CITY OF ALBUQUERQUE

**Planning Department
Transportation Development Services Section**

Re: Certification Submittal for Final Building Certificate of Occupancy for
Gateway West Business Park(Phase 2), [K-9 / D23]
8551 Saul Bell Road NW
Architect's Stamp Dated 02/26/07

Re: **Clifford West Business Park Grading and Drainage Plan** ~~(K-9/D23)~~
Engineer's stamp 9-12-97

APPENDIX B
STORM DRAIN

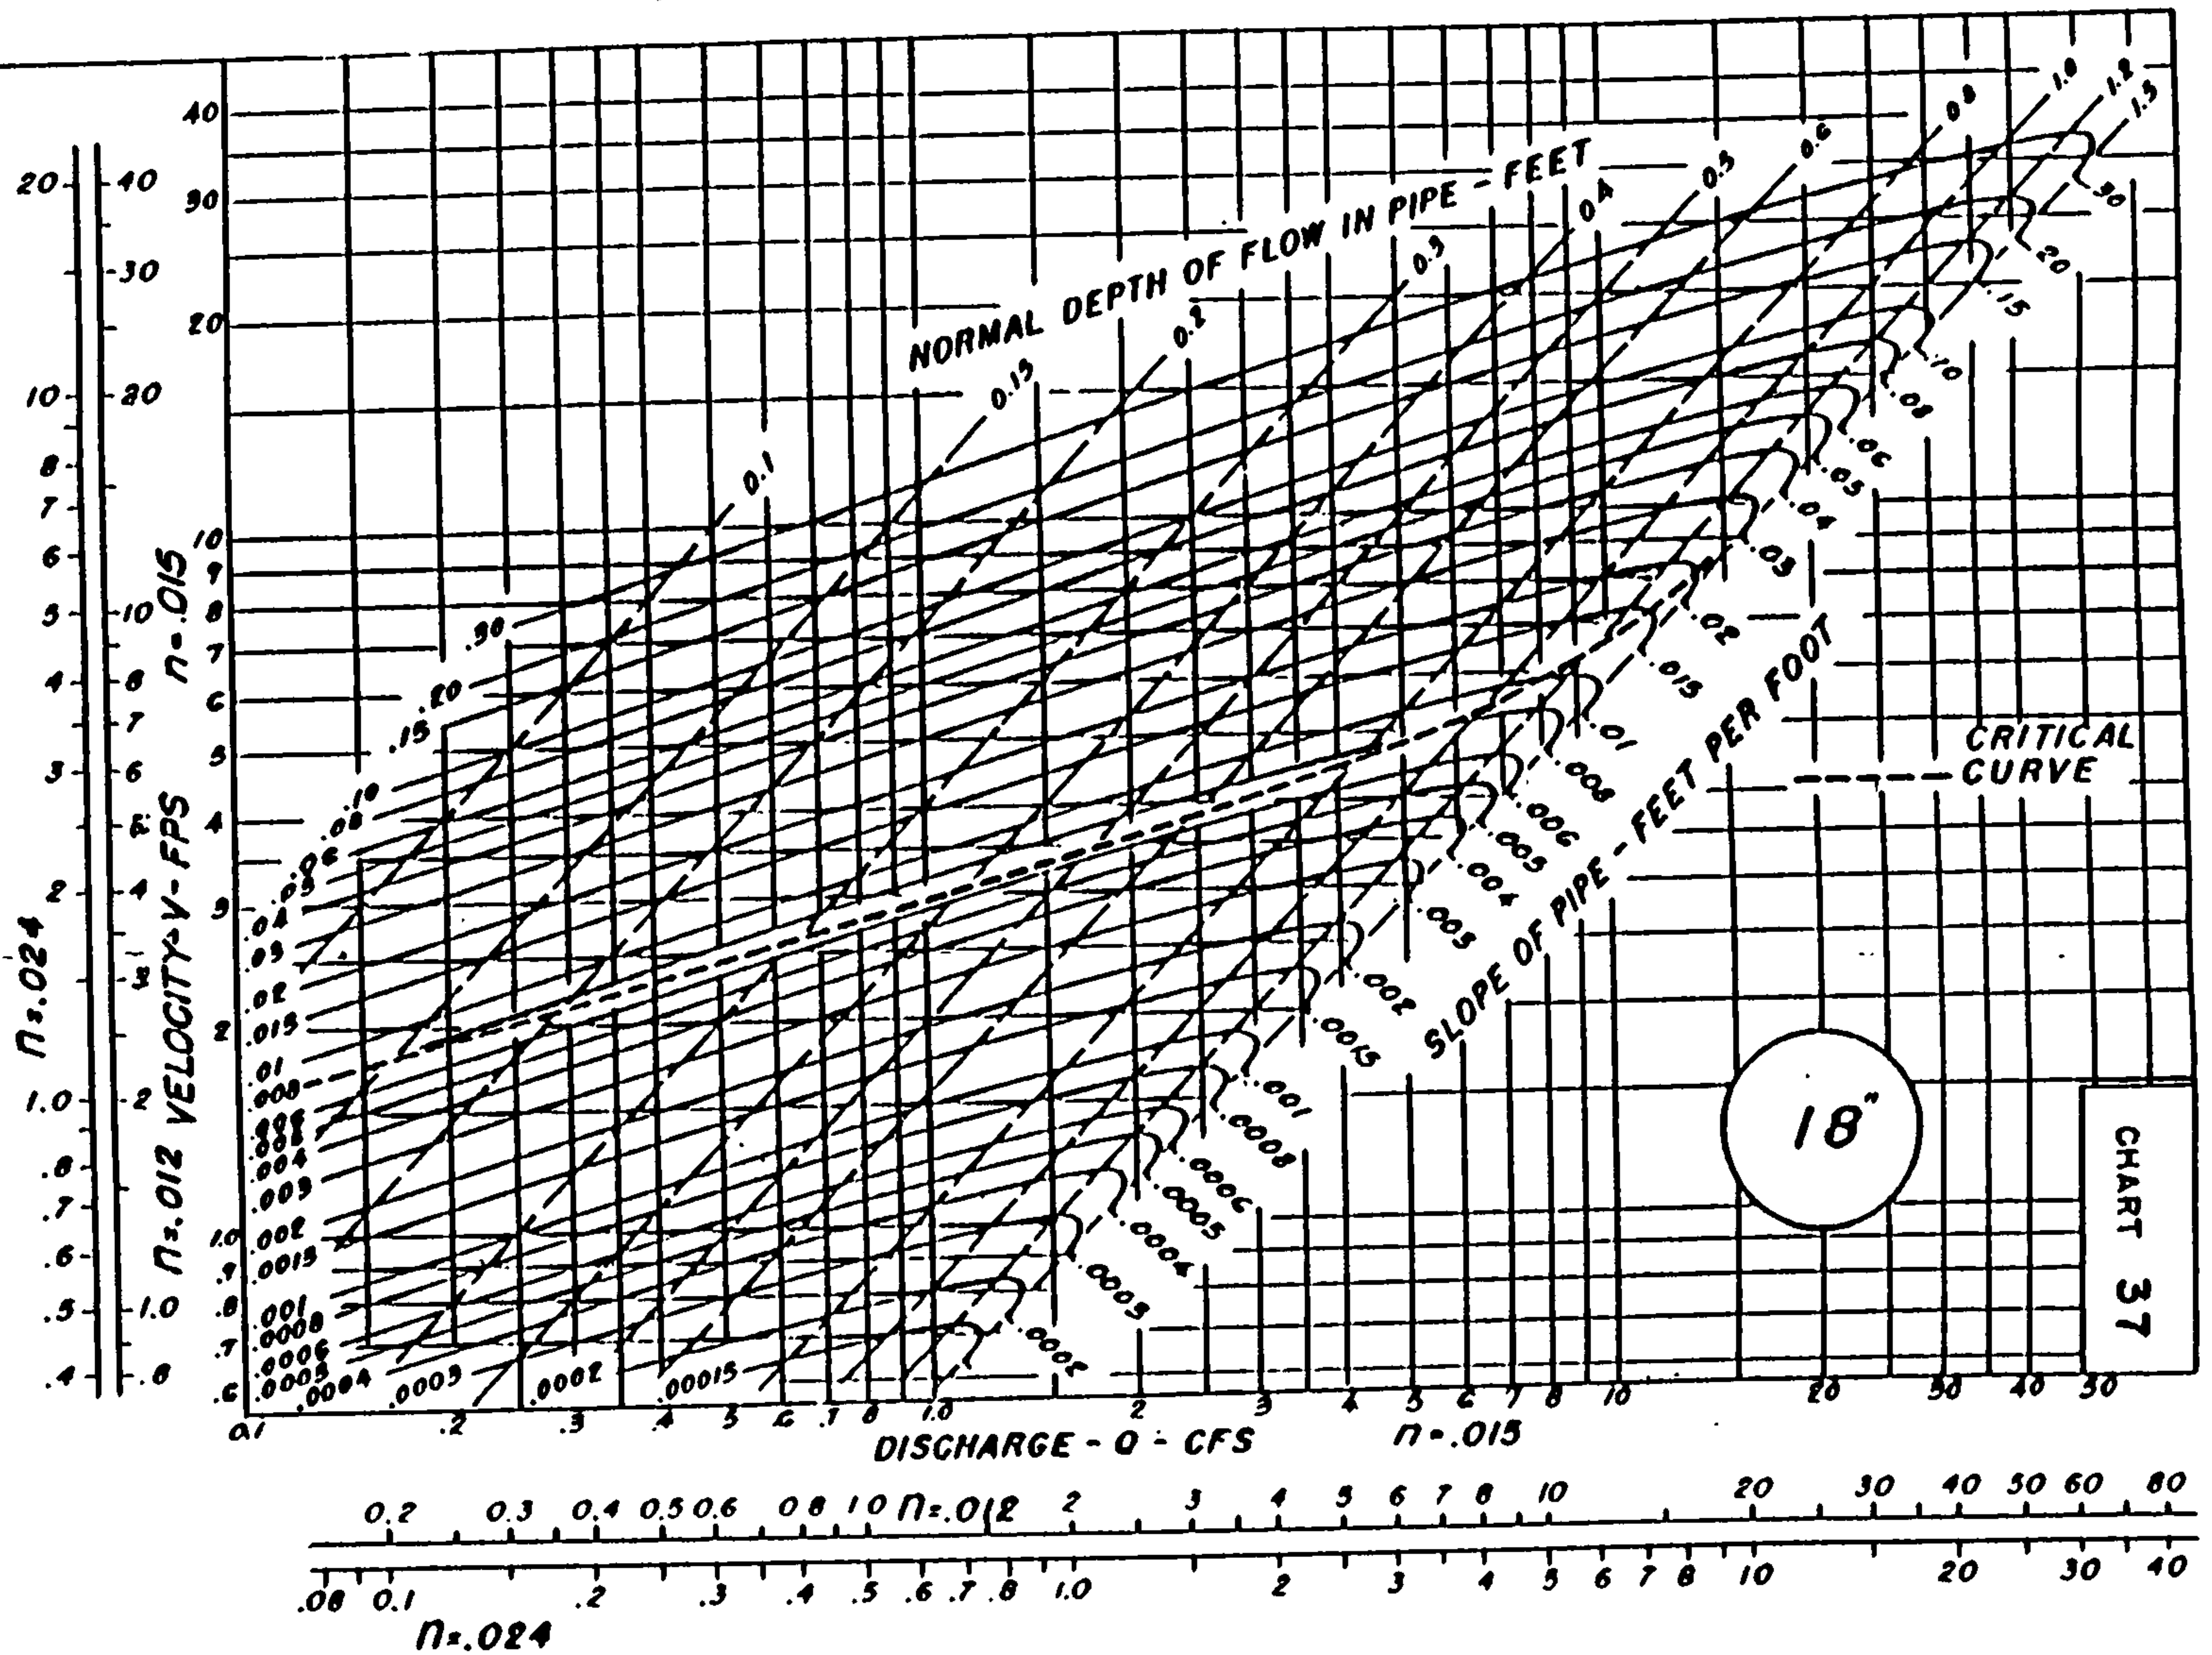
If drainage off of each lot requires an 18" SD directly into the main line, there will need to be a manhole at each service storm drain intersection with the main storm drain.
